**KING COUNTY HOUSING AUTHORITY
REQUEST FOR BIDS
MARINA CLUB MECHANICAL AND ELECTRICAL**

ADDENDUM #2

Effective 5/8/2024, this Addendum #2 shall be considered part of the Request for Proposal Documents.

Marina Club Bid Walk Questions

1 bedroom before demo

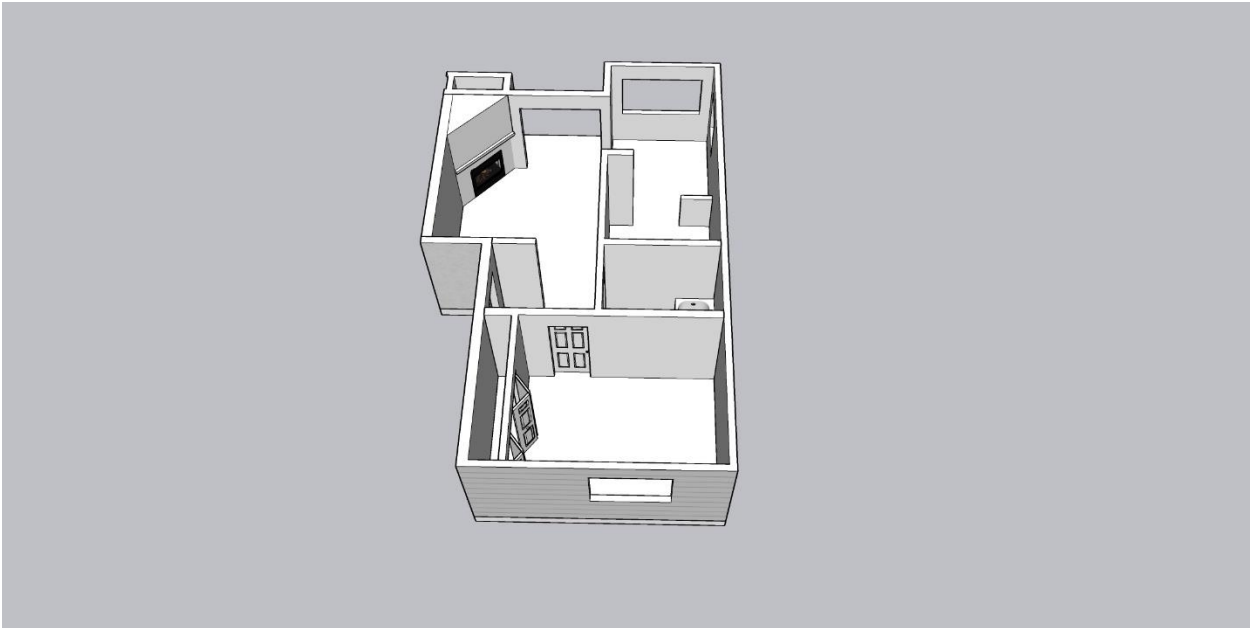
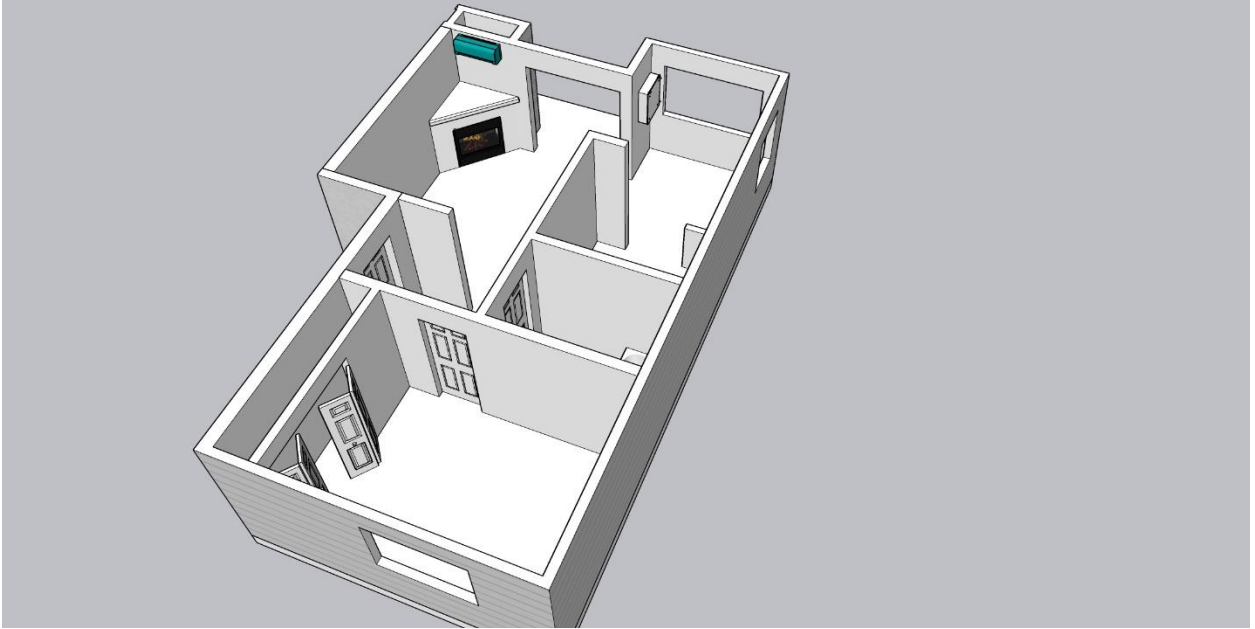
- 1 bedroom, 1 bath units Buildings B,D,F twenty four (24) total at Marina Club Apartments have diagonal facing fireplaces in the living room. The demo will consist of demo above the fireplace to square off walls for Mitsubishi DHP head.
- Remove existing sheet rock and studs above fireplace, existing wall behind diagonal wall will be sheet rocked and fire taped.
- Remove piping from old fireplace, air seal wall, patch hole in ceiling
- Texture and paint to match existing walls
- Install counter top on top of fireplace

1 bedroom after demo with DHP and Fresh Box installed
